SURREY COUNTY COUNCIL - RESPONSE TO ExQ1 C.A.1.40

GATWICK AIRPORT NORTHERN RUNWAY PROJECT DCO

PINS Reference: - TR020005

Masterplan Diagram

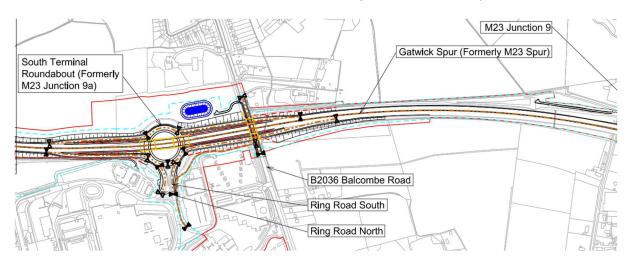
- 1.6. Having regard to Policy HOR9 SCCaL commissioned a masterplan assessing the capacity for employment space at Bayhorne Farm. The layout plan below shows the access arrangements that must be put in place in order to mitigate against the impact of the Project on SCCaL's ownership and the wider site allocation.

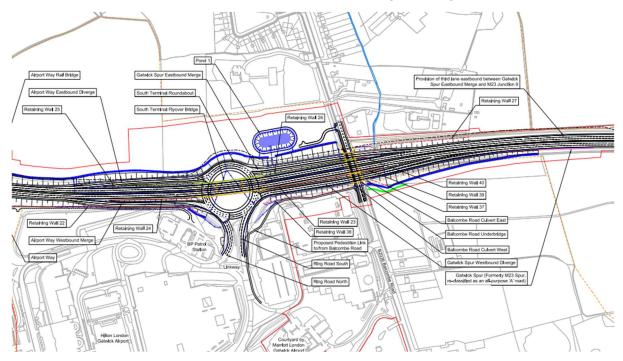
- 1.7. The Project will undertake both temporary and permanent re-alignment works on Airport Way to support the construction and operation of the Project. These works are set out in Work No. 35 in Schedule 1 of the draft DCO.
- 1.8. Surface Access Parameter Plan 41700-XX-B-LLO-GA-200101 (extract below of STR/Bayhorne Farm) sets out the proposed layout for approval. This layout should not be approved without inclusion of the mitigation requested by SCCaL.

- 1.14. In order to mitigate the impact of the Project on development at Bayhorne Farm, SCCaL asks:
 - 1.14.1. Work No.35 is amended to ensure a permanent access from STR, "the Bayhorne Farm Access Road", into Bayhorne Farm is included, if necessary, by way of a change request;

- 1.14.2. The relevant surface arrangement plans and other plans and application documents are amended to show the permanent access on a new alignment and that the new alignment is agreed in advance with SCCaL prior to issue;
